**Re: FW: World Kitchens Site****Kenneth Bardo** to: Cornuet, Thomas

WORLD KITCHEN, INC.  
MASSILLON, OHIO FACILITY  
Prepared for Wyeth, Madison, New Jersey

NORTH AREA SVE SYSTEM ENHANCED REMEDIATION PLAN				
DATE	M J Y		DATE	7/12/10
SCALE	1"=20'		DWG. NO.	108
	B O NO		029940020130002	REV.

Tom - Our risk assessor reviewed the "Indoor air assessment for former EKCO facility in Massillon, Ohio" dated June 12, 2006, and noted a few discrepancies in the calculations. Modifications were made and the indoor air risk was re-calculated.

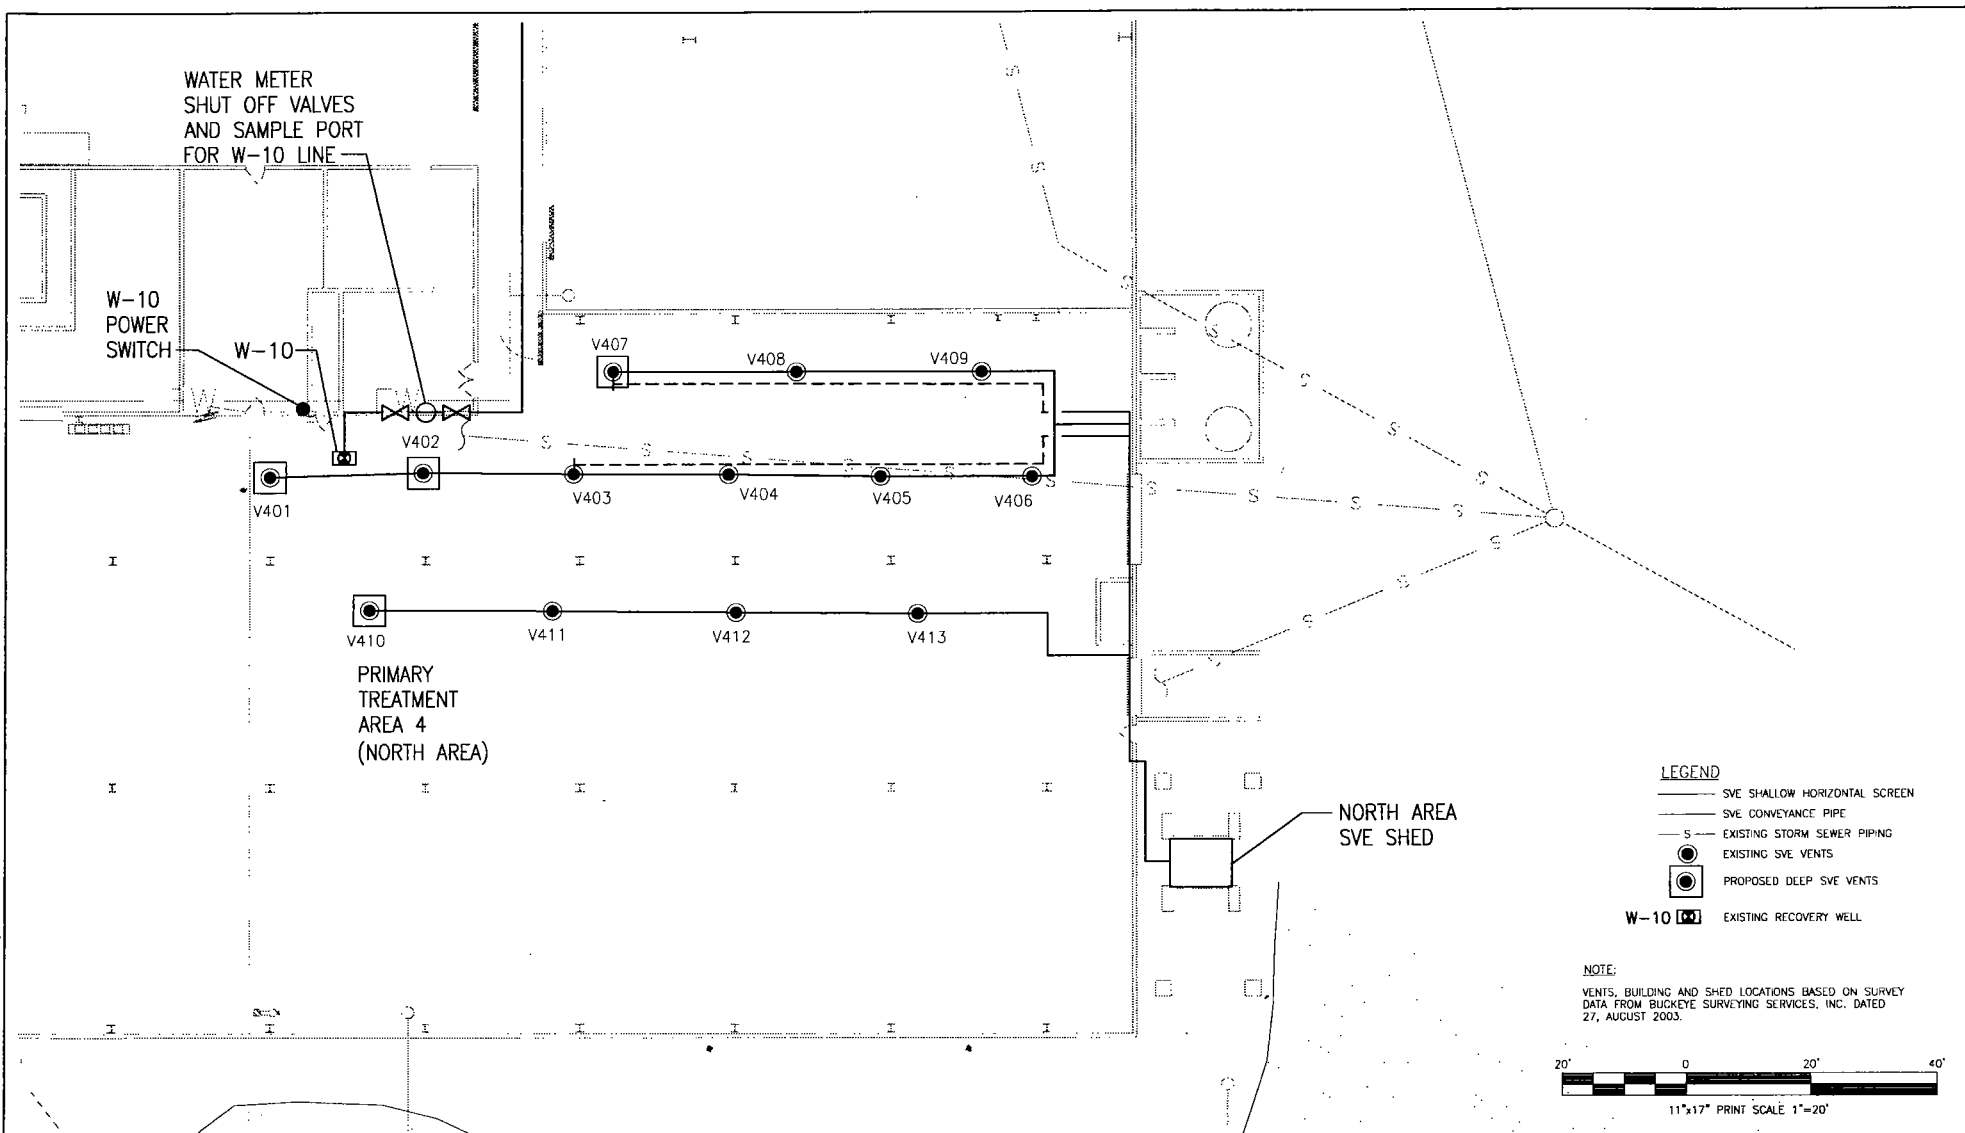
Tom, thanks for the update proposing the additional work for the North Area SVE system at the World Kitchen site in Massillon, Ohio. Applying a vacuum to well W-10 and installing deeper SVE wells close to well W-10 seems like a good approach for trying to extract additional VOCs from potential source areas within the unsaturated deposits. If these additions to the North Area SVE system are productive enough to increase the pounds of VOCs removed per year to significantly greater than the one ton per year "de minimis" permit exemption, EPA recommends that remediation continue to be performed and that the GAC units be reinstalled on the SVE system. Please let us know the results of the project. Thanks, Ken

The first phase of our SVE System modification simply consists of applying a vacuum to the deep groundwater extraction well W-10, utilizing the existing blower system that is currently connected to the 13 shallow extraction wells. The second phase, which is currently scheduled for late July or early August, will consist of installing deeper SVE wells at 4 of the current 13 shallow well locations which are located closest to well W-10 (V401, V402, V401, and V410). The 4 new deeper wells will serve to replace the existing shallow wells at those locations and the total depth of the deeper wells is currently planned to be approximately 40 feet below ground surface. The final well depths may vary some based on field screening data collected during well installation. The 4 new deeper wells will be connected to the existing SVE blower system using the same blower and conveyance piping that the shallow wells currently use.
